CHARLESTON COUNTY COUNCIL PUBLIC HEARING Tuesday, December 6, 2022 at 6:30 PM

a. <u>ZREZ-07-22-00137</u>: Request to amend PD-152, Buckland Plantation Planned Development, to PD-152A, Buckland Plantation, to allow for different lot configurations, an additional waterfront lot, community docks and updates to meet wetlands, stormwater, and current Planned Development requirements.

PD-152A: BUCKLAND PLANTATION AMENDMENT REQUEST ZREZ-07-22-00137 CASE HISTORY

WET AREA ADJACENT TO 4045 Belvedere rd. WITH VIEW OF HOME

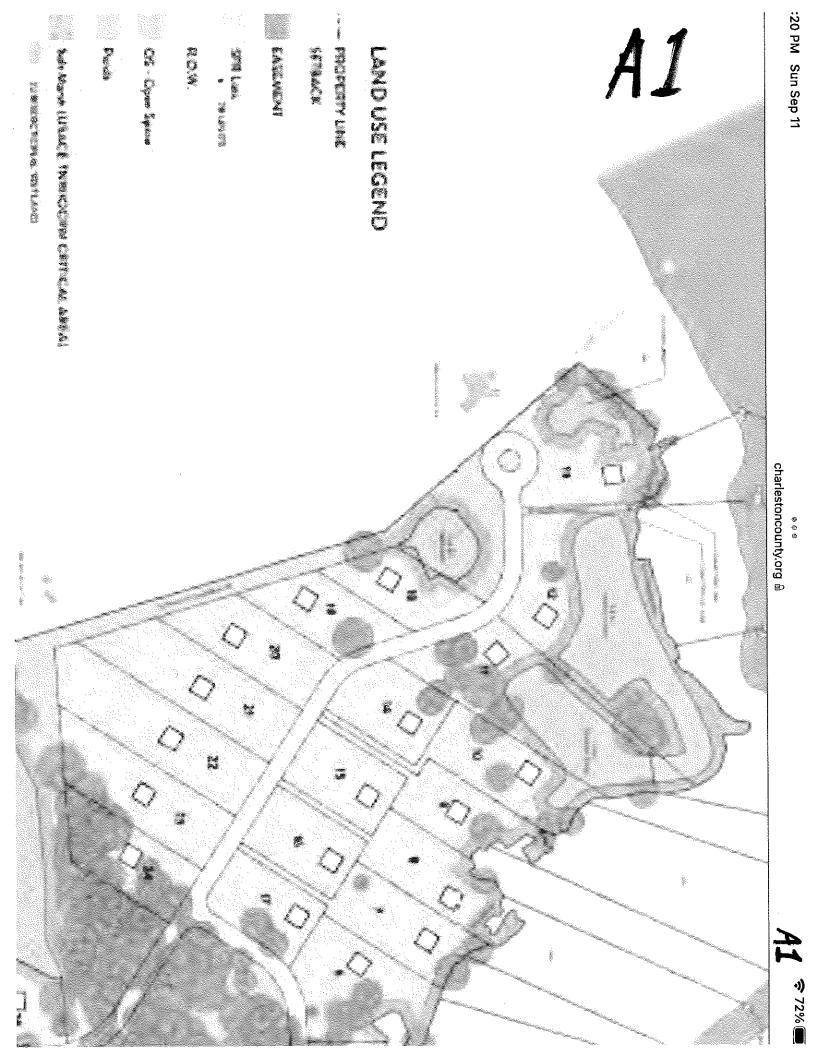
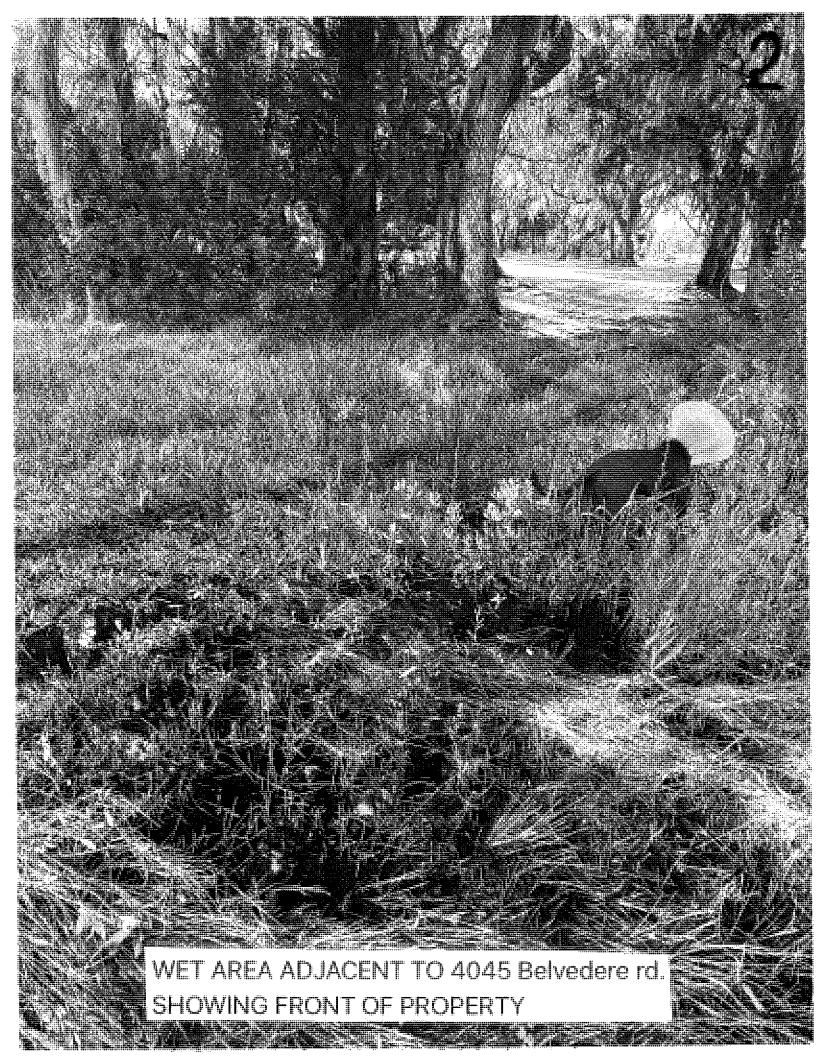
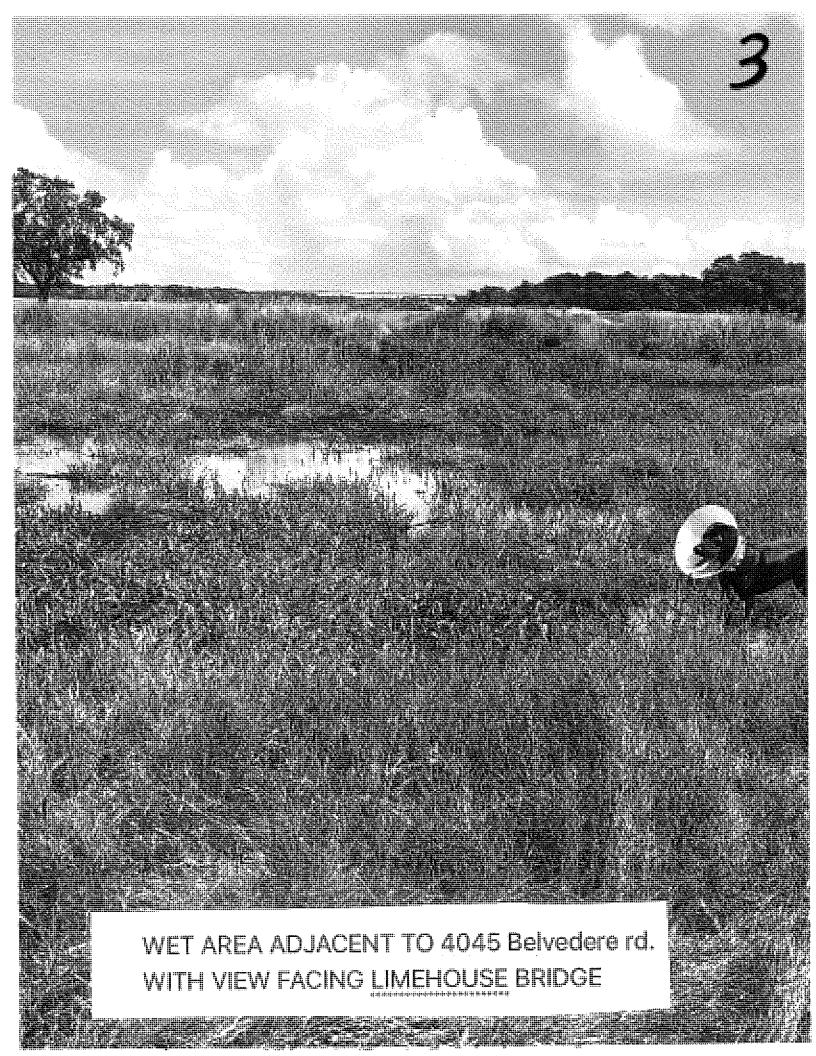
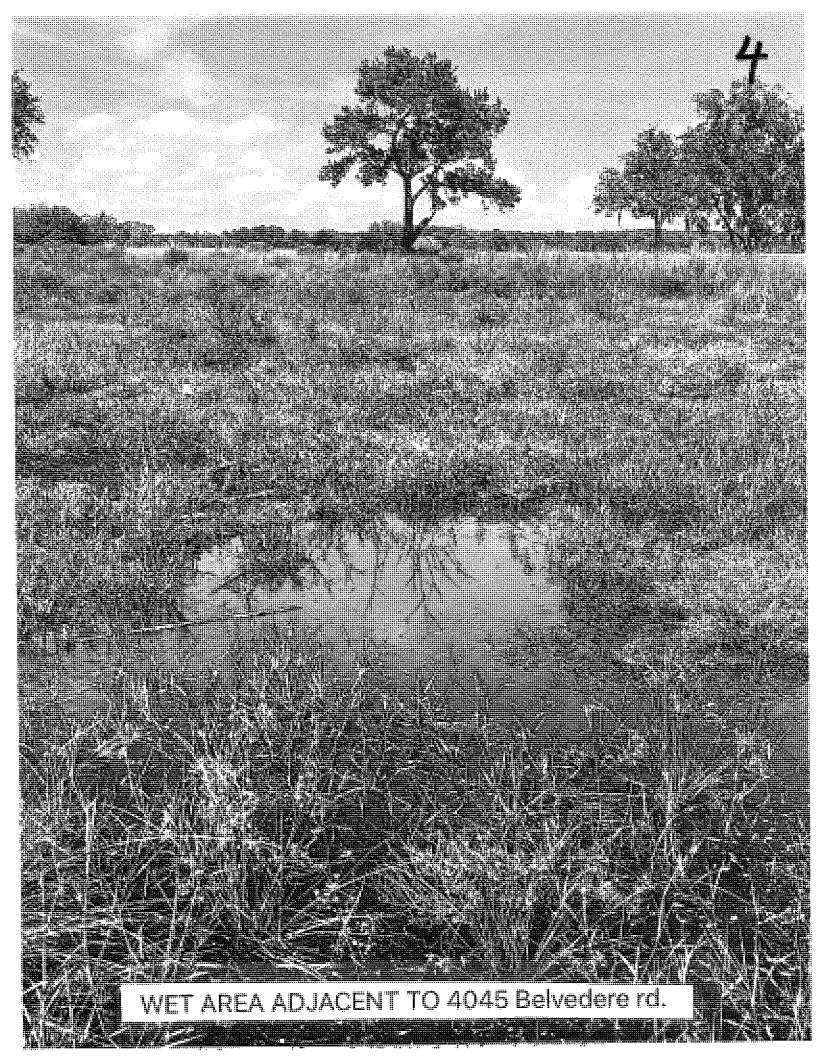
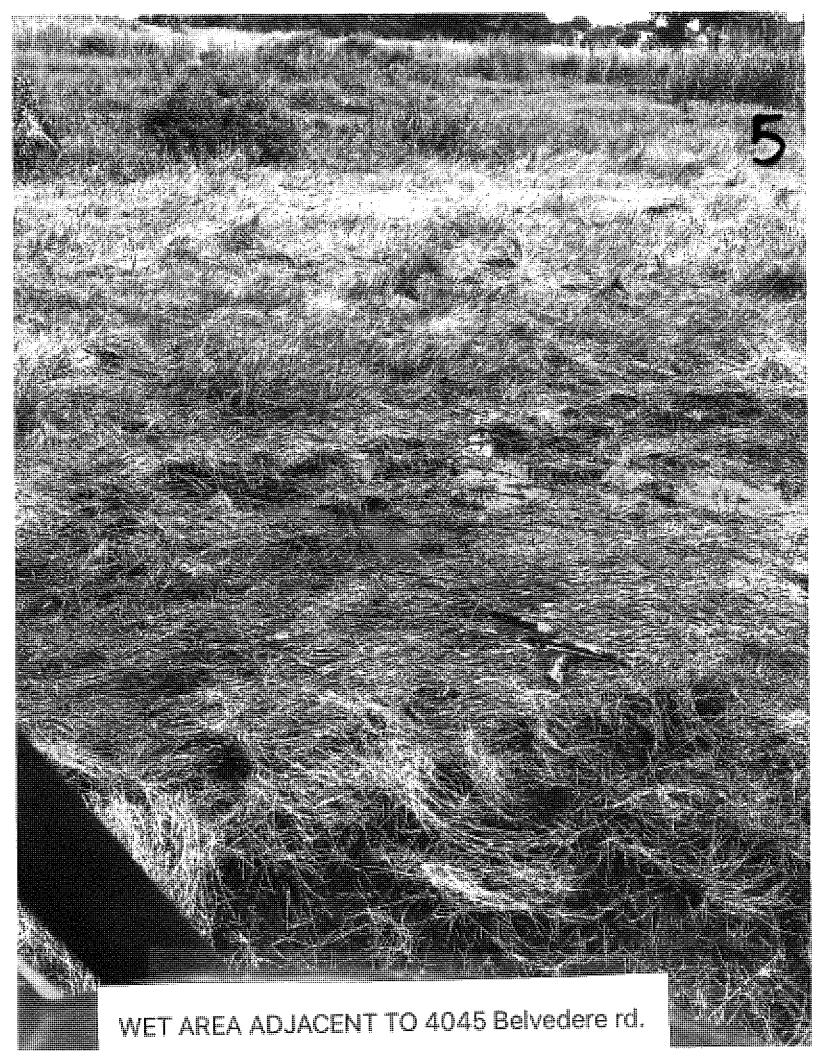
You can see in the photos 1-5 that wet lands are right against my property ... if you fill in that long strip of low land it WILL flood my property.

DRY AREA FACING GRIMBAL GATES AND RANTOWLES CREEK

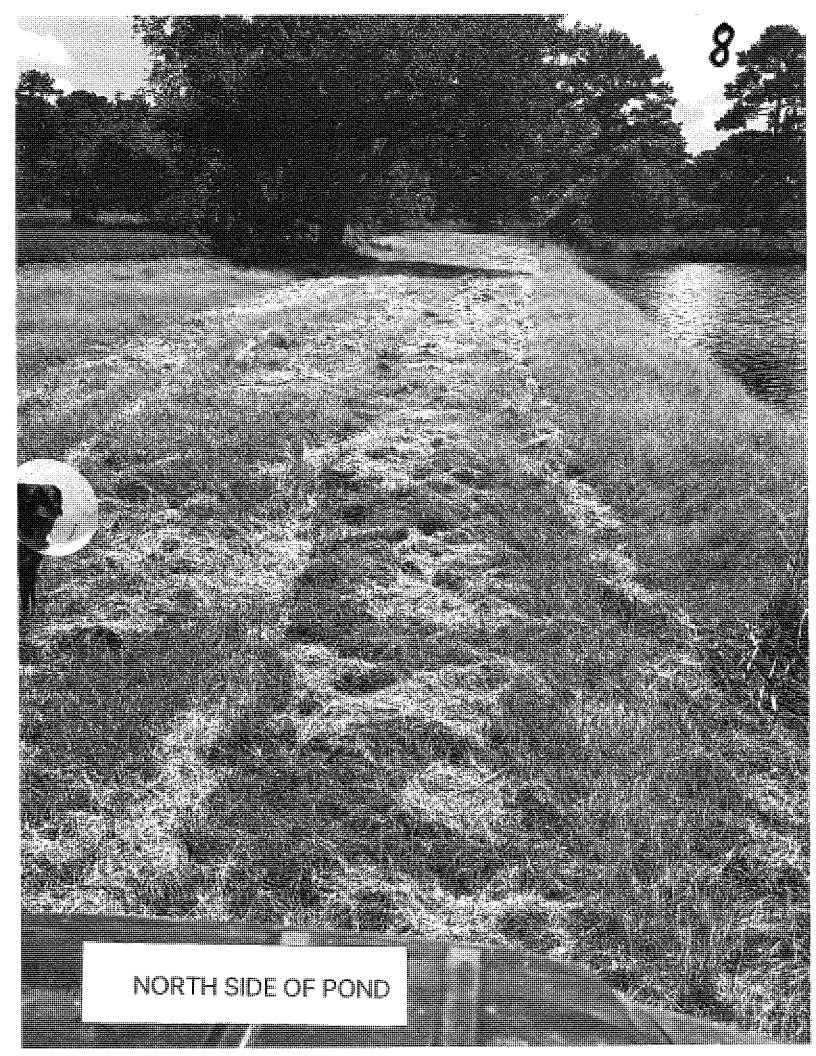
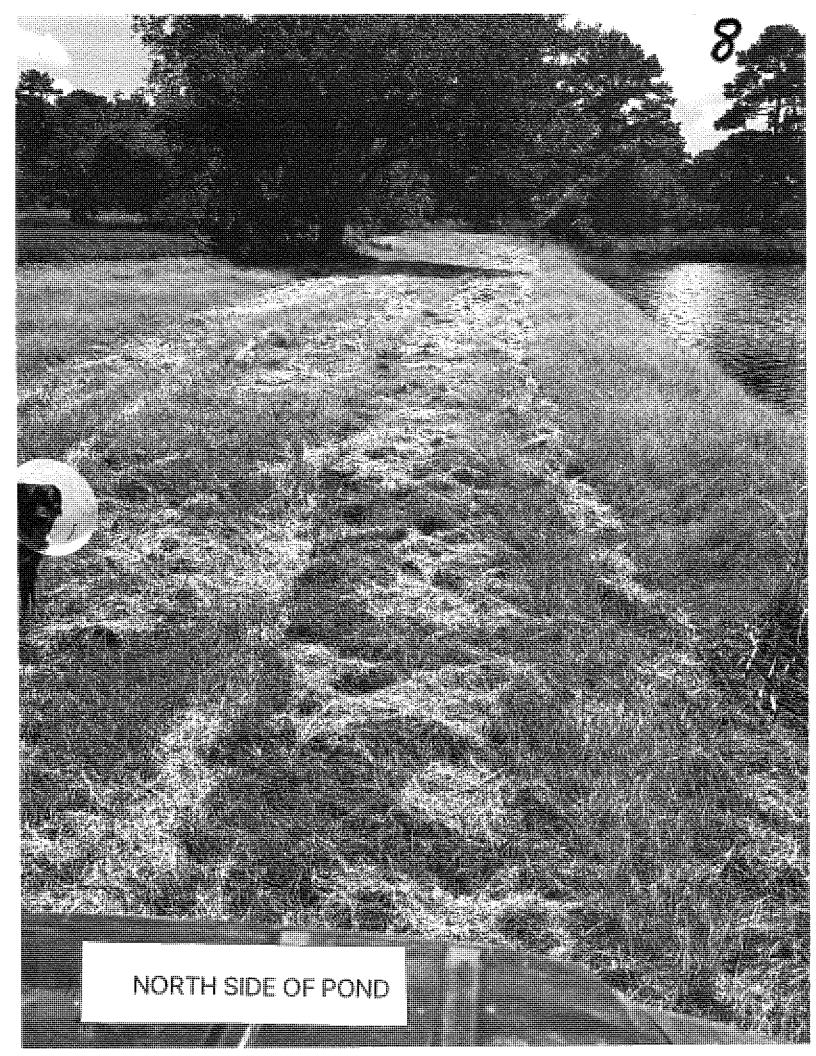
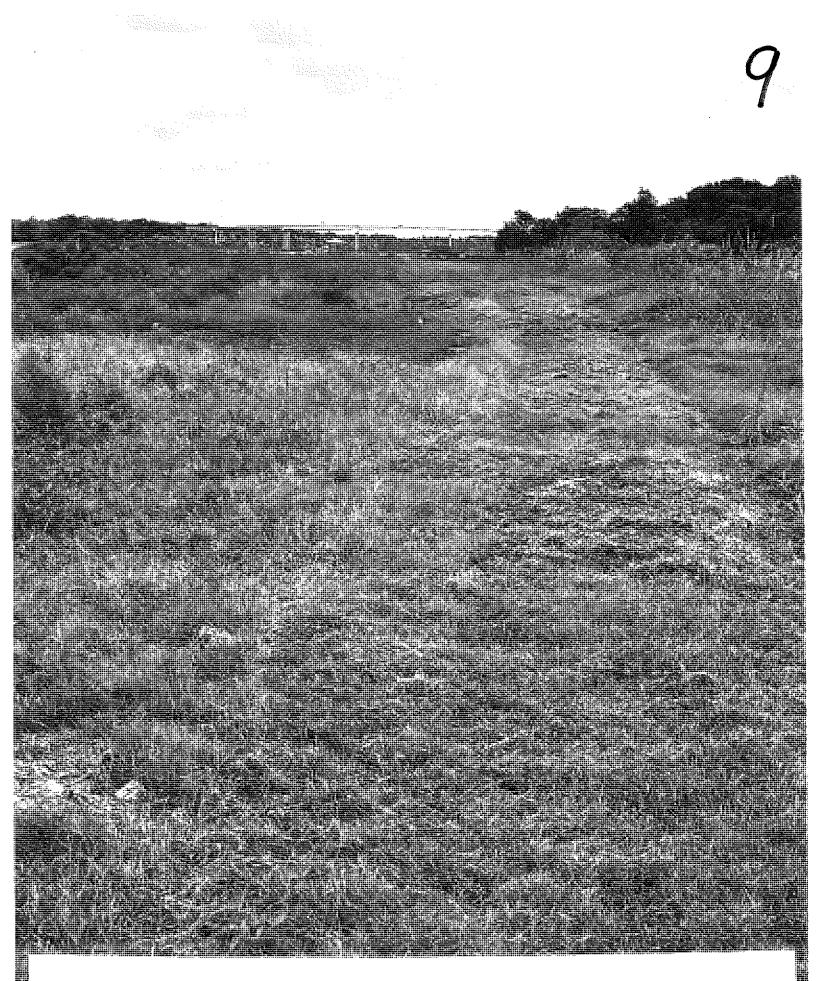
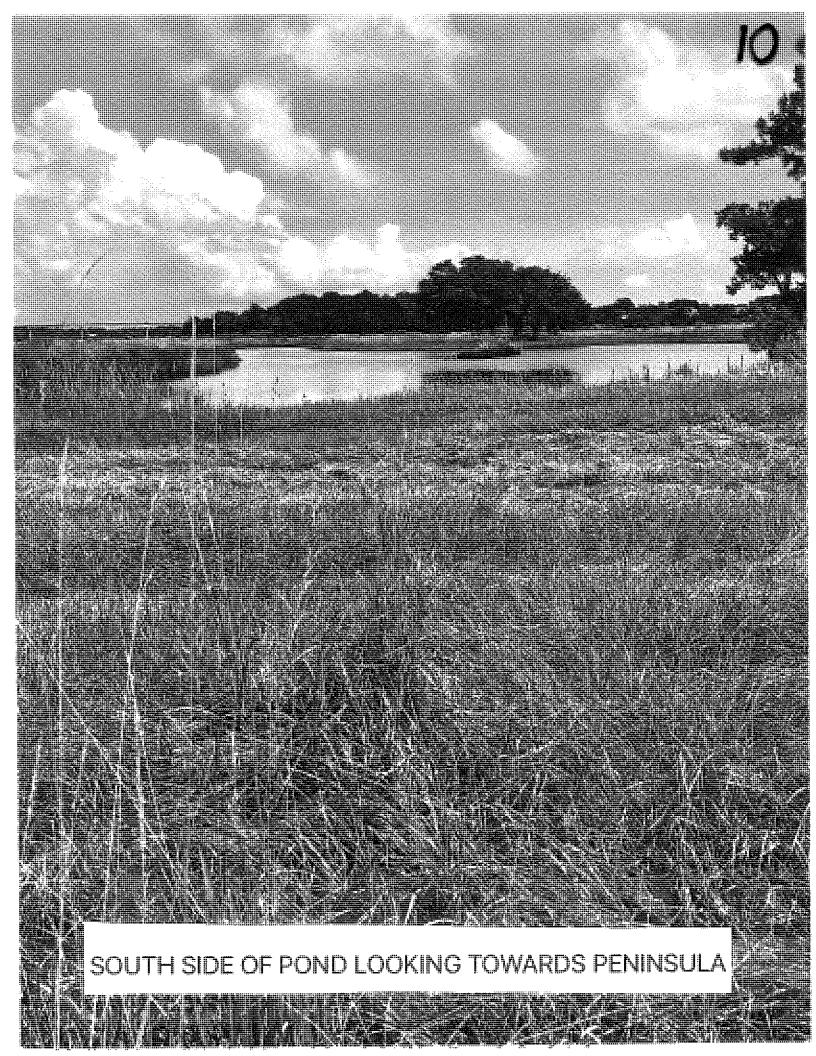
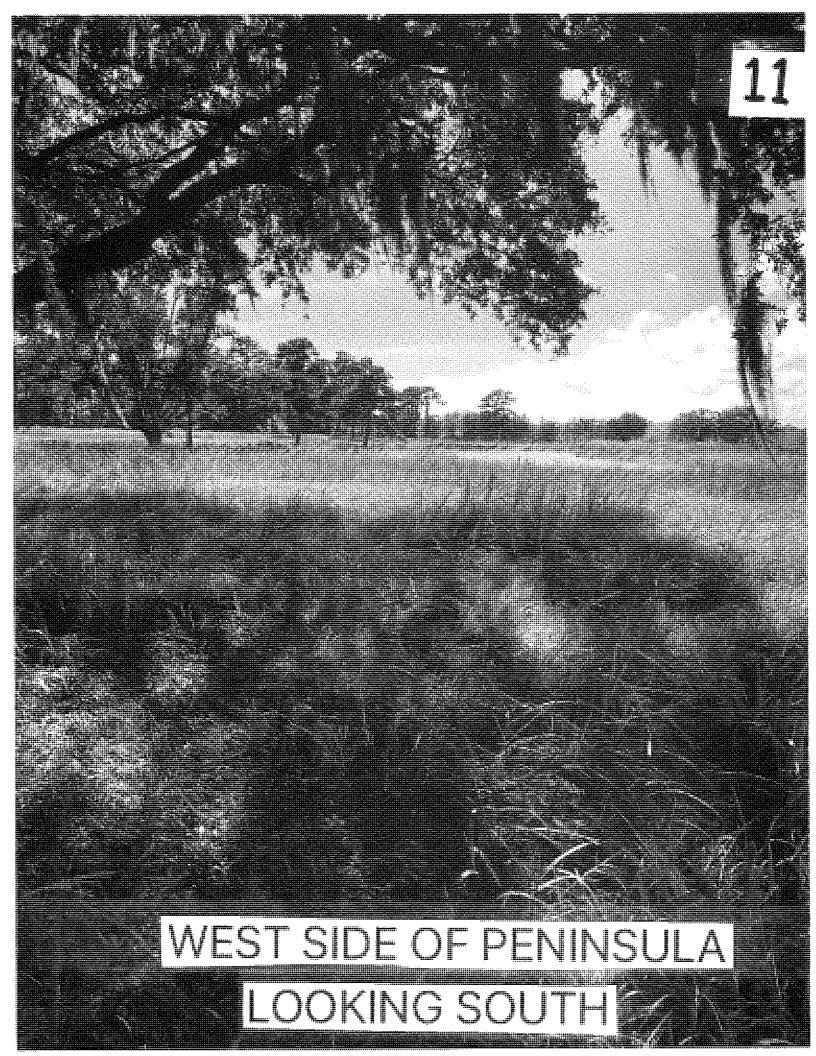
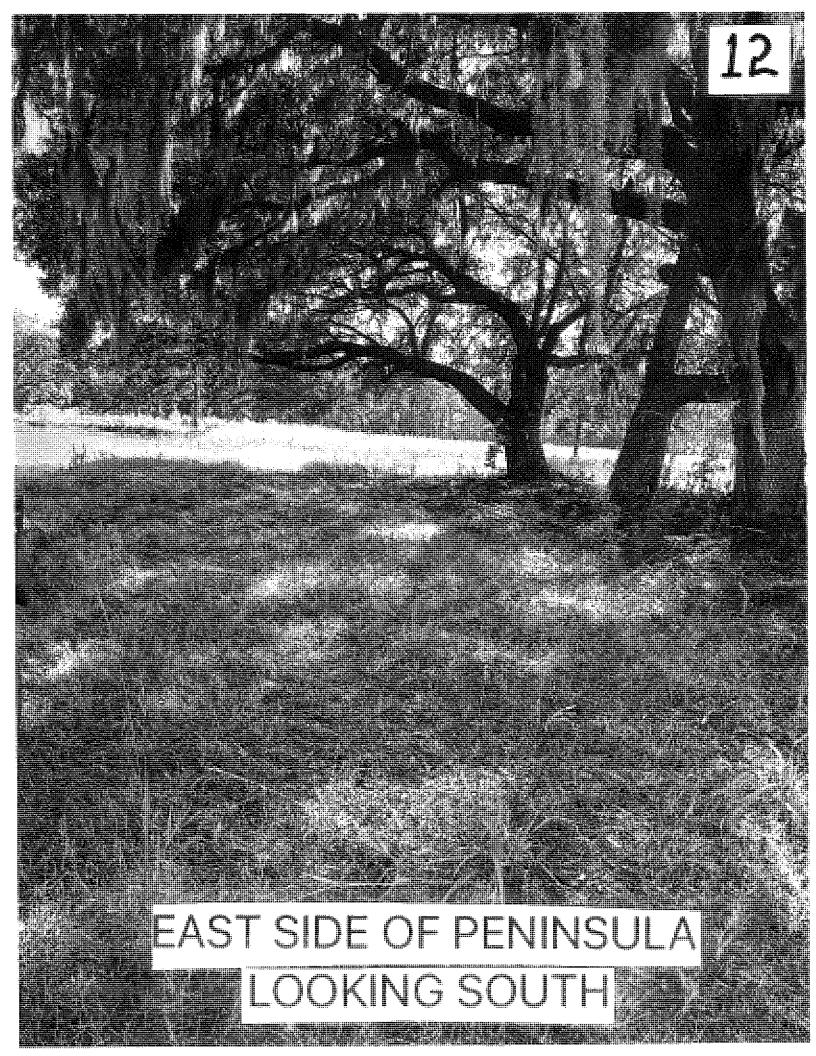
Photos 6-9 addresses alternative places to make your turn around instead adjacent to my home. One of the options are high areas of land on the North side of the property. Also the land between the pond and the Stono river is usable for parking.

Photos 10-12 are of the Peninsula that is a spacious area for parking and gathering.
